Economic Commission for Europe
Inland Transport Committee
World Forum for Harmonization of Vehicle Regulations
Working Party on Lighting and Light-Signalling
Seventy-second session

Geneva, 20 - 22 October 2014

Report of the Working Party on Lighting and Light-Signalling on its seventy-second session
Contents

"1. Front position lamps

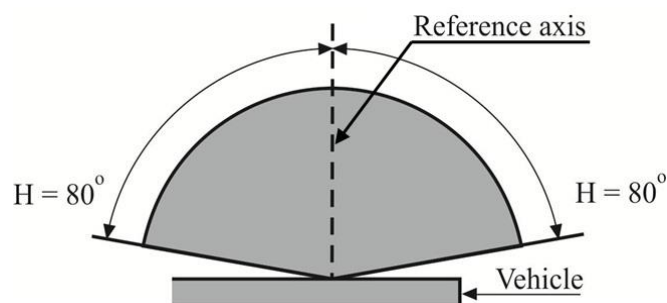
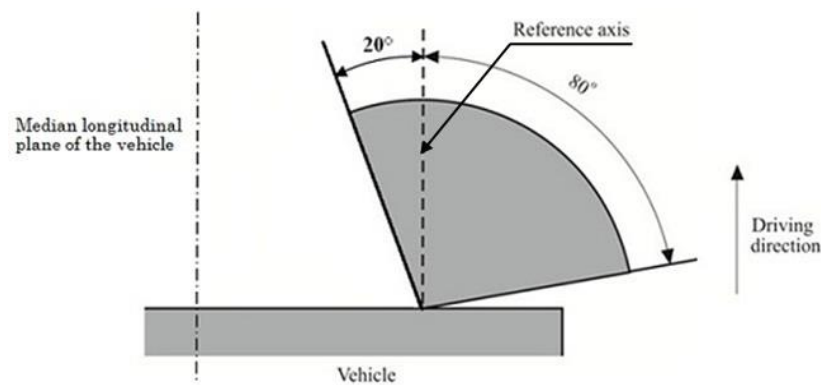
$$V = +15^\circ / -10^\circ$$

However, in the case where a device is intended to be installed with its H plane at a mounting height less than 750 mm above the ground, the angle of 10° below the horizontal may be reduced to 5° .

Front position lamps (for a pair of lamps)

$$V = +15^\circ / -10^\circ$$

However, in the case where a device is intended to be installed with its H plane at a mounting height less than 750 mm above the ground, the angle of 10° below the horizontal may be reduced to 5° .

"2. Rear position lamps

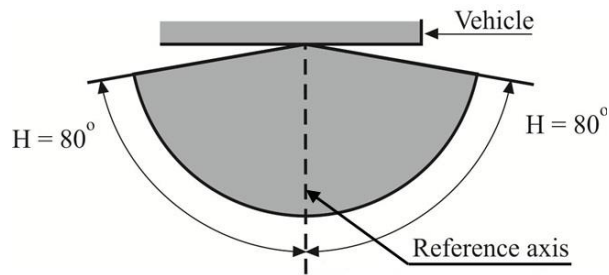
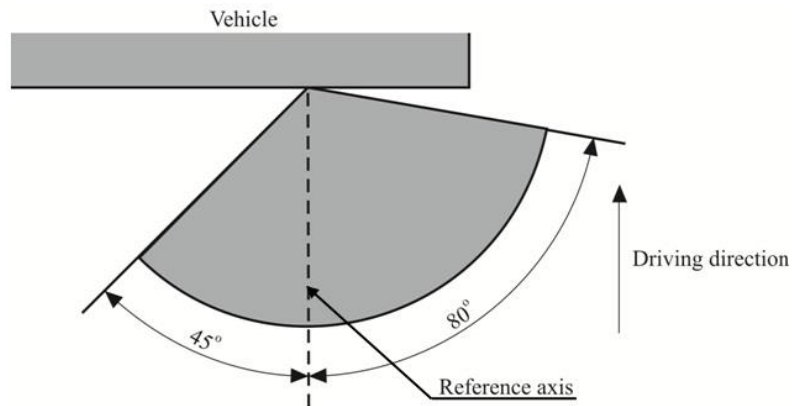
Paragraph 2., amend the diagrams to read:

$$V = +15^\circ / -10^\circ$$

However, in the case where a device is intended to be installed with its H plane at a mounting height less than 750 mm above the ground, the angle of 10° below the horizontal may be reduced to 5° .

Rear position lamps (for a pair of lamps)

$$V = +15^\circ / -10^\circ$$

However, in the case where a device is intended to be installed with its H plane at a mounting height less than 750 mm above the ground, the angle of 10° below the horizontal may be reduced to 5°.

Category 11c:

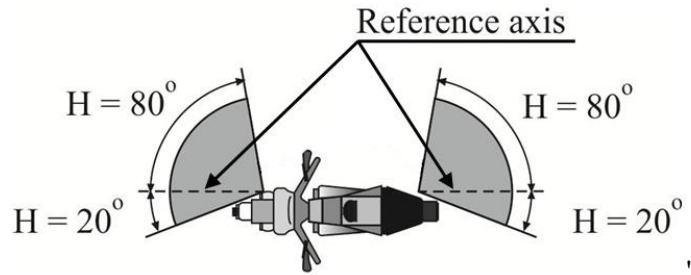
for use at a distance less than 20 mm from the passing beam headlamp.

- "4. Stop lamps
 $V = +15^\circ/-10^\circ$

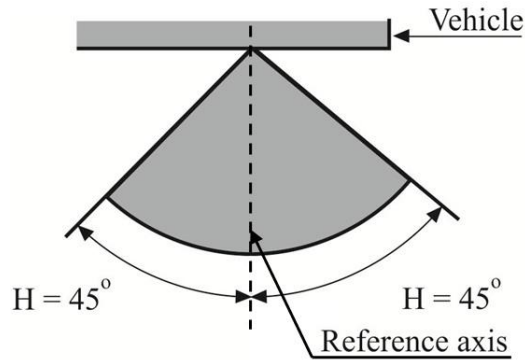
Paragraph 4., amend the diagram to read:

However, in the case where a device is intended to be installed with its H plane at a mounting height less than 750 mm above the ground, the angle of 10° below the horizontal may be reduced to 5°.

However, in the case of a pair of lamps, the inboard geometric visibility requirement is deemed to be satisfied if the lamps conform to the photometric values prescribed in the field of light distribution for the approval of the device.
